Torque Converter Flex Lock-up Shudder

Service Category Drivetrain

Section Automatic Transmission/Transaxle

YEAR(S)	MODEL(S)	ADDITIONAL INFORMATION
2013 - 2015	RAV4

Figure 1. Magnet Installation Locations

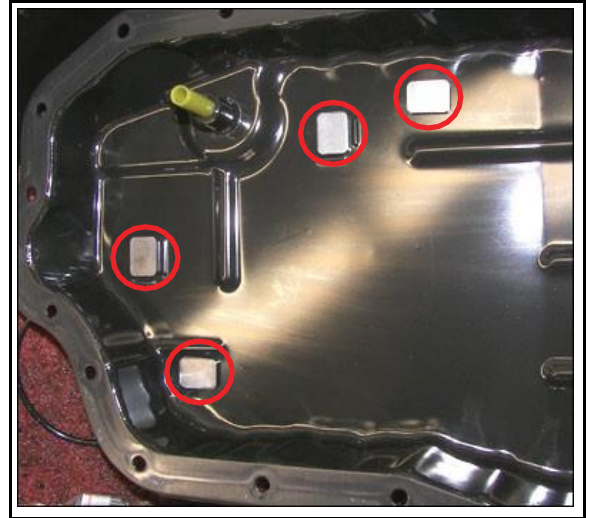
6. Install four NEW magnets as shown.

Figure 2. Location of Authorized Modifications Label on 2013 – 2015 RAV4

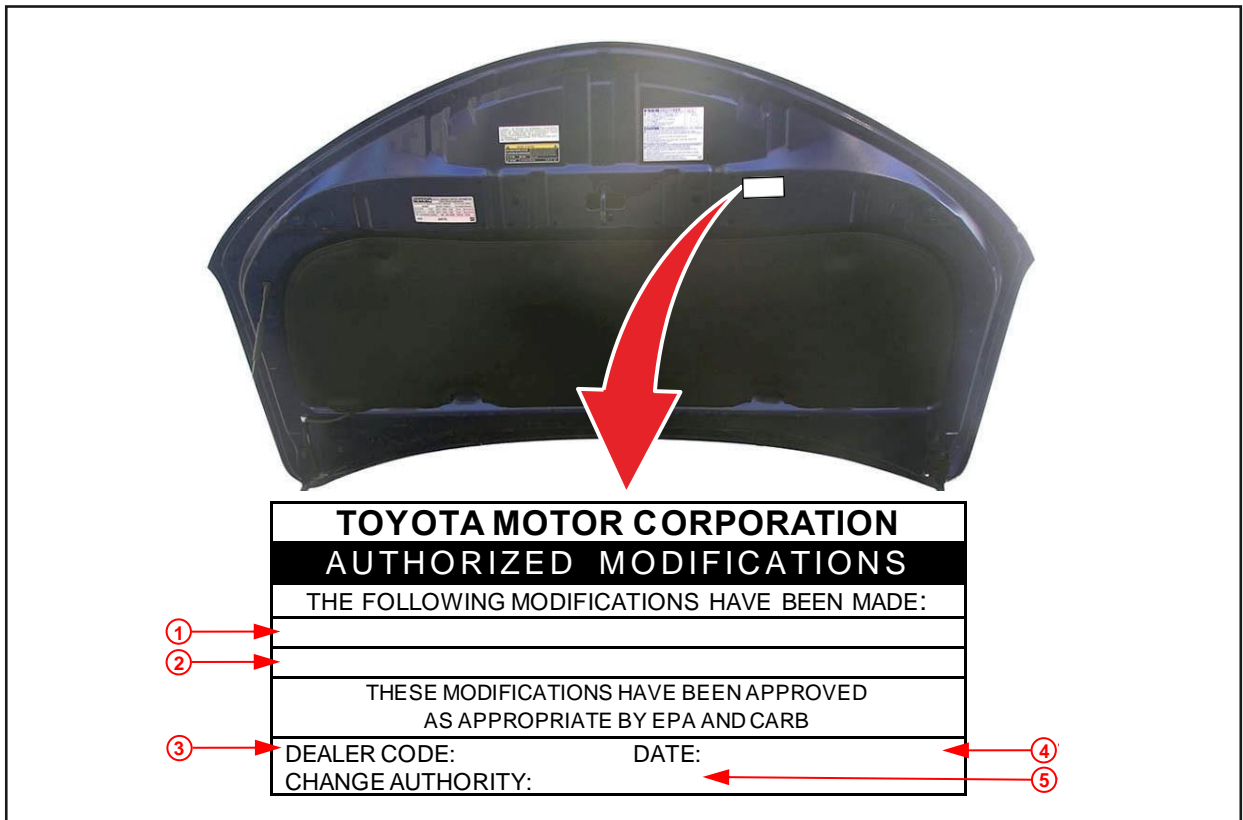
- Use Techstream to confirm if the ECM (PCM) calibration has been updated and check for the Authorized Modifications Label affixed to the vehicle in the location shown below.

Is the calibration ID listed in Techstream and on the label the latest ECM (PCM) calibration?
